City of Maple Ridge
Advisory Design Panel
MEETING MINUTES
May 18, 2022 Regular Meeting

6.1 Development Permit No: 2021-061-RZ / 21783 Lougheed Highway.

The Chair welcomed the project team to the meeting and introduced the members of the ADP. The Staff Liaison provided a brief overview of a 6-storey 121-unit apartment building with some ground floor commercial in the C-7 Zone. A previous submission was made before the ADP meeting held on March 23, 2022. The ADP requested that changes be considered by the applicant. The ADP requested

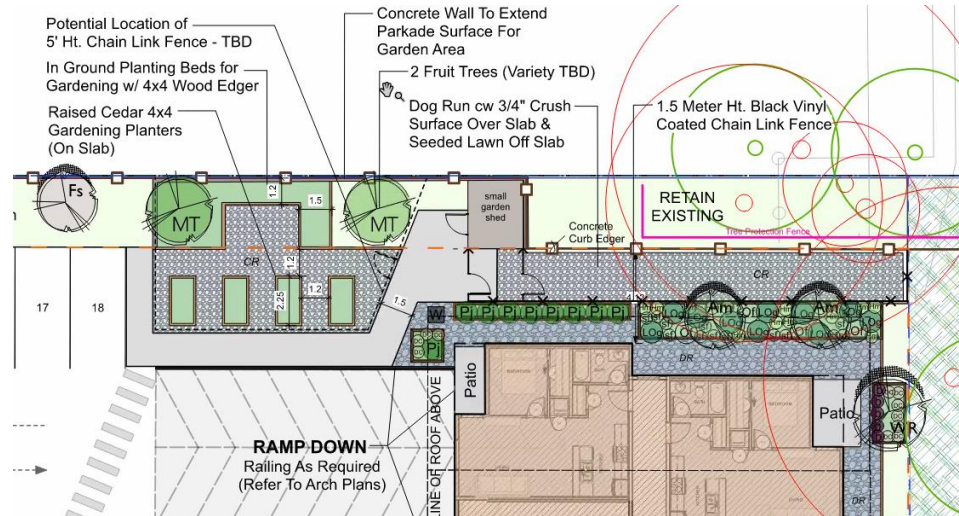
- Ensure the refuse access door can accommodate larger bin sizes.
- Ensure adequate headroom at parking ramp for refuse pickup vehicle.
- Consider adding access at the north end of the corridor at ground level for residential outdoor amenity area.

- The amenity areas proposed need to fulfill the Development Permit guidelines as well as, *Zoning Bylaw 2019-7600*.
- The mounded grass area indicated as amenity space for residents with the singular trees should be enhanced for privacy and programmability to ensure that it can be functionally used by the residents of the building.

- The amenity area proposed at the north east corner has opportunities to include additional programming, for example child play.
- Recommend relocating the commercial door next to the lobby door on slab amenity space to provide greater separation between public and private space.

- Recommend rotating planting beds separating commercial amenity and private amenity to ensure more complete separation of space.
- Ensure proposed sod areas on slab are flush with hard paved walking surfaces.

- Recommend that the chain link fencing enclosing the community garden space be reconsidered with softer material.
- Consider removing the sod from the community garden area and expanding the community garden plots.

- Consider relocating the garden shed within the community garden fenced area.
- Confirm construction of retaining wall and garden shed on the community garden area is allowed within setback.

- Provide cross sections for amenity area from neighbouring property to building to identify height of proposed retaining wall and materiality.

- Provide cross sections and details and how grade change will be achieved at tree protection area and all interfaces with adjacent properties.
- Provide details on how the grade changes will transition with the statutory right-of-way and the single family residential homes located to the north. Ensure landscape grading plan resolves interface with the existing trees. Ensure, if permitted, that the exposed portion of the retaining wall is aesthetically pleasing to the residential use to the north, consider setback and screening.

- Ensure the storm water on sloped sod landscape at north property line is captured onsite.
- The proposed retaining wall may require a fence, due to a fall height issue.

- The proposed sod along the northern property line may present maintenance issues.
- Ensure stormwater report and plans are provided to Planning Staff with resolution of storm water drainage on north and west property line.
